TIME

A circle is the perfect shape for time. Its shape has no beginning or end but is forever moving. Time is defined by our orbit around the sun, revolving continuously in the form of circles. Clocks, sundials, and the solar system reflect this shape. The merry-go-rounds are positioned around walls representing the sun and night sky, allowing one to feel the passage of time while spinning. Time is also relative, it flies by when you're having fun. The merry-go-rounds are linked at different speeds to reflect the planets' orbital velocity, becoming both controllable and uncontrollable. The wide colorful bands on the exterior reference Lella and Massimo Vignelli's Dot watch design, and also serve to link colors with the merry-go-round's respective planets: Mercury, Earth, Jupiter, and Mars.

Roller Chain Detail

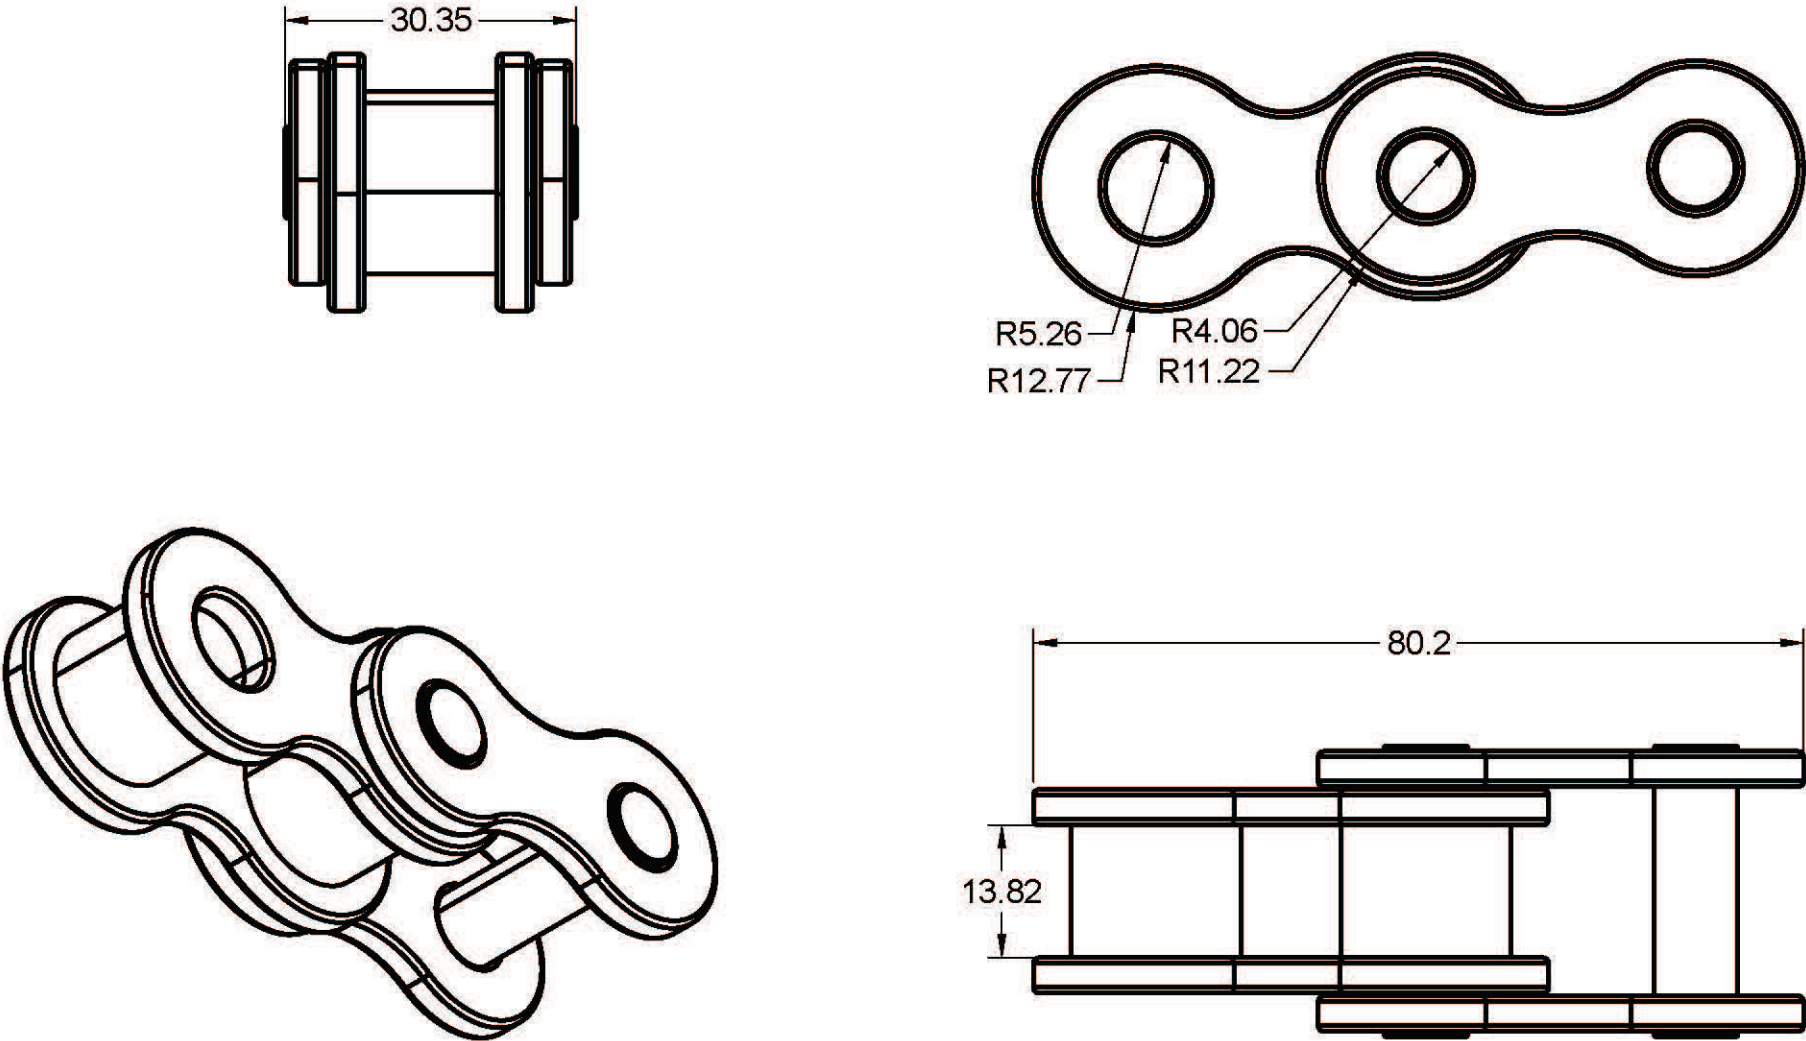
Large scale roller chains are a cheap and simple way to link the wheels, and there are a ton of examples of uses, especially within farm equipment

Addition of supports along the length of the roller chain would be needed

Inclusive Handlebar Detail

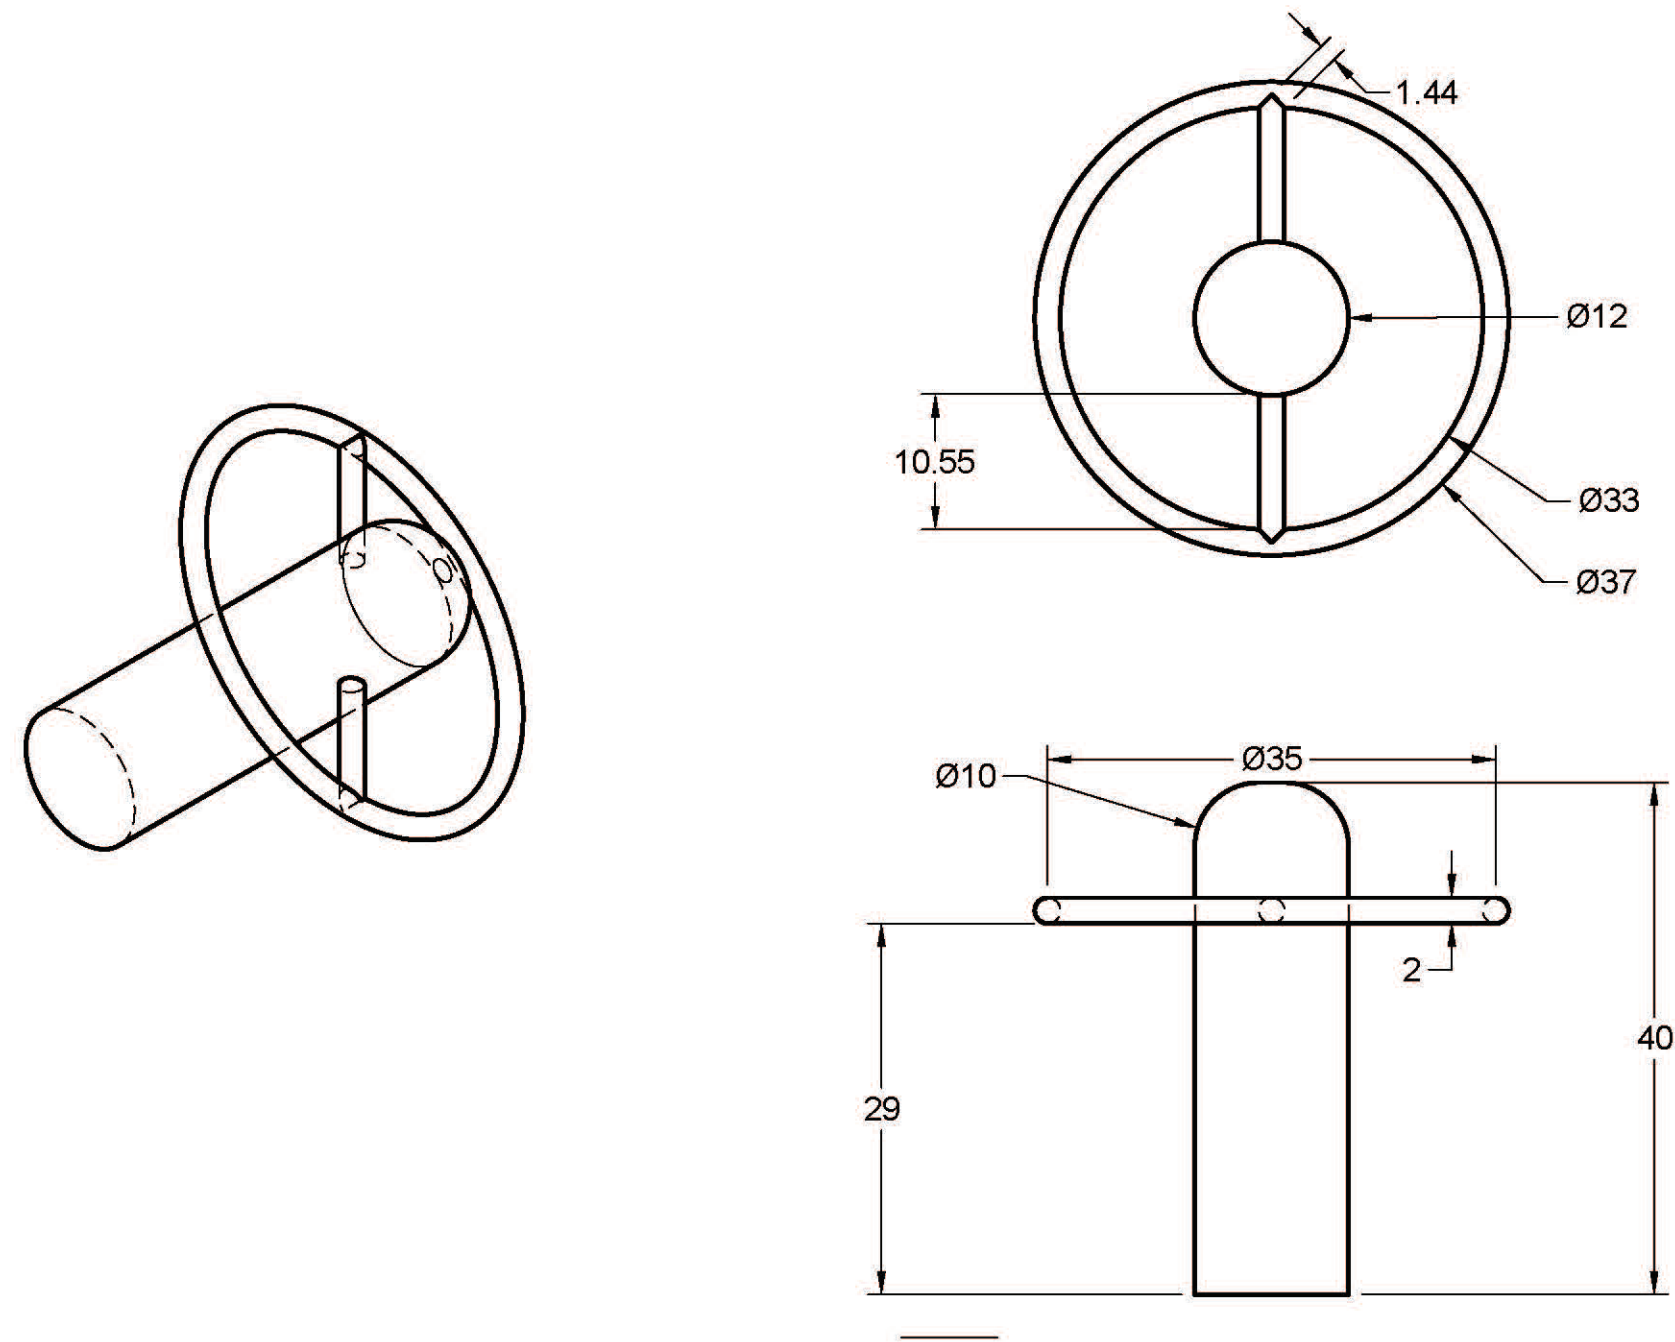
Addition of a cog spinner so the merry-go-round can be spun from the inside, allowing wheelchair users to be able to use it more effectively without assistance

Poured-in-Place Rubber Playground Surfacing

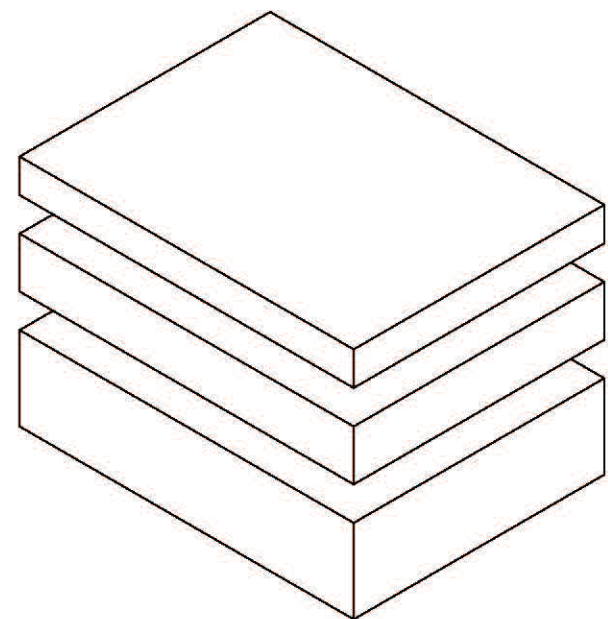
Suggestion of poured-in-place rubber or Astroturf, the later of which needs an anti-static spray since too much static can discharge medical equipment, such as cochlear implants
